CDM: Recommendation Form for Small Scale Methodologies (version 01)

<i>Date of SSC WG meeting:</i>	27–30 October 2009, SSC WG 23
<i>Title/Subject (give a small title or specify the subject of your submission, maximum 200 characters):</i>	Clarification on AMS-III.Q for project activity using incremental gain of waste heat recovery
<i>Indicative methodology to which your submission relates (refer the items of Appendix B of the Simplified Modalities and Procedures), if applicable.</i>	AMS-III.Q, version 02
<i>Name of the authors of the query:</i>	Deepak Jain Institution: Deepak.jain@maruti.co.in

SSC-Submission number	SSC_359
Date when the form was received at UNFCCC secretariat	30 October 2009
Date of transmission to the EB	30 October 2009
Date of posting in the UNFCCC CDM web site	30 October 2009

Below is the diagram showing the baseline and project activity scenarios.

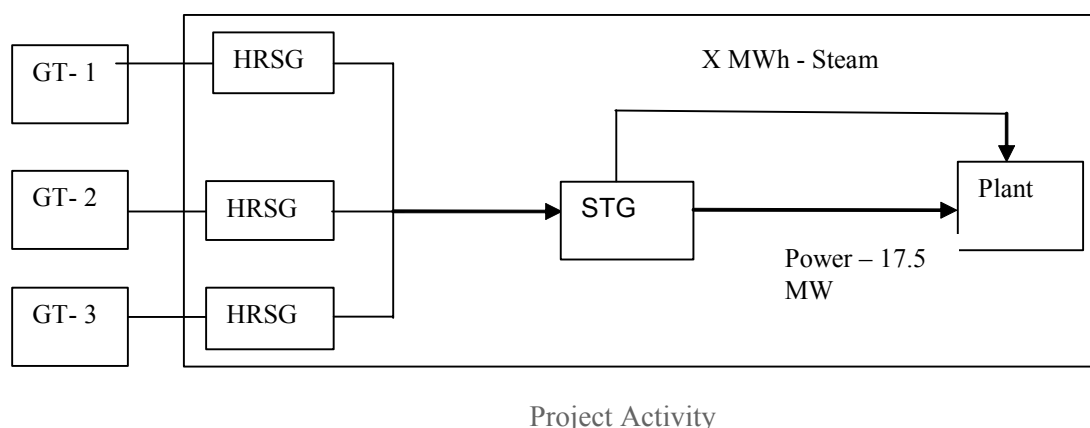
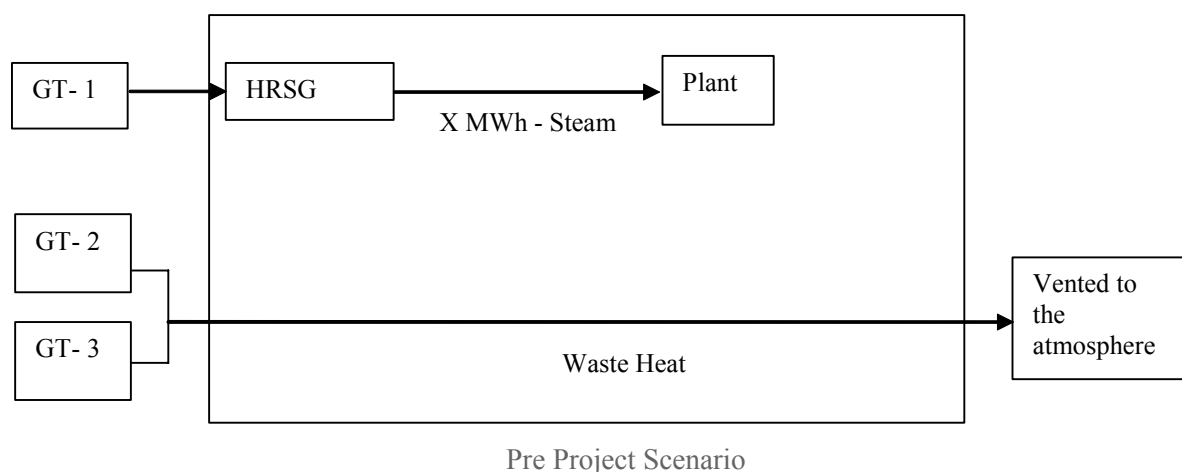
In this project only heat (steam) is generated from a portion of the waste heat in the baseline scenario with no captive electricity generation in the baseline scenario. The quantity of steam generated in the project scenario would remain the same as in the pre project scenario.

Query 1: It is noted that in the pre-project scenario the project activity is generating steam using the waste gas from one of the gas turbine but there is no information on the steam generation parameters like quantity, pressure, temperature, presence of PRDS etc.

Query 2. The submission is unclear on what will happen to the existing HRSG post implementation of the project activity?

Query 3. It is noted that the process steam-energy generated in the project scenario would be same as in the pre project scenario. The waste heat generated from other two gas turbines on site is not utilizable for any other purpose on-site except to generate power. Please clarify why this underlying project cannot be considered as combined cycle electricity generation project?

Paragraph 3 of AMS-III.Q states “The recovery of waste gas/heat may be a new initiative or an incremental gain in an existing practice”. Based on the further information provided by the submission author, it is noted the existing practice in the operation of the gas turbine will be altered as a result of the implementation of the project activity (e.g., NG consumption and Waste heat generation will be reduced as compared to its baseline). This may lead to the operation of the generating equipment on a part load condition with a lower efficiency.

As regards clarification whether the approach described in ACM0012 version 3 (Scenario 1a.ii.(2), page 17/54) to determine baseline emissions from electricity generation for Type 2 activities can be used in AMS-III.Q for the underlying project, the SSCWG agreed to clarify that ACM 0012 is not applicable to projects where the waste gas/heat recovery project is implemented in a single-cycle power plant (e.g., gas

It is to be noted that the basic assumption of AMS-III.Q is the operation of the equipment where the waste energy carrying medium (WECM) is generated is not affected as a result of the project activity, which is not the project case. The project proponent may consider submitting a new methodology taking into account the above issues.
